CIRCULATION
GENERAL

TELEPHONE No. 192 C.B. - MODIFIED FOR AUTO WORKING.

FOR USE WITH REPEATER TELEPHONIC No. 9A
ON AUTO SYSTEMS.

N. 292.A

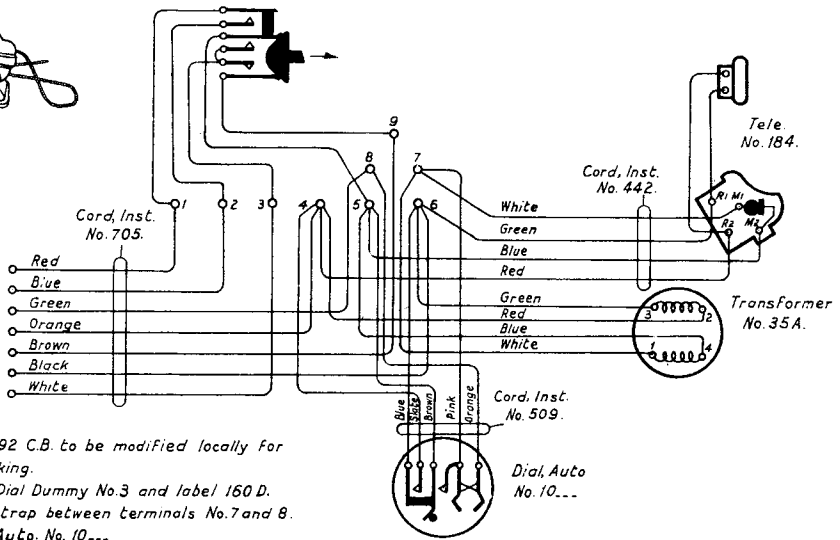
*SUPERSEDED BY TELE No. 226CA
& REPEATER TELE No. 17A
SEE N. 326, N. 1802 & N. 1813.*

- Tele. No. 192 C.B. to be modified locally for Auto. working.
- Recover Dial Dummy No. 3 and label 160 D.
- Remove strap between terminals No. 7 and 8.
- Fit Dial, Auto. No. 10...
- Fit Cord, Inst. No. 509.
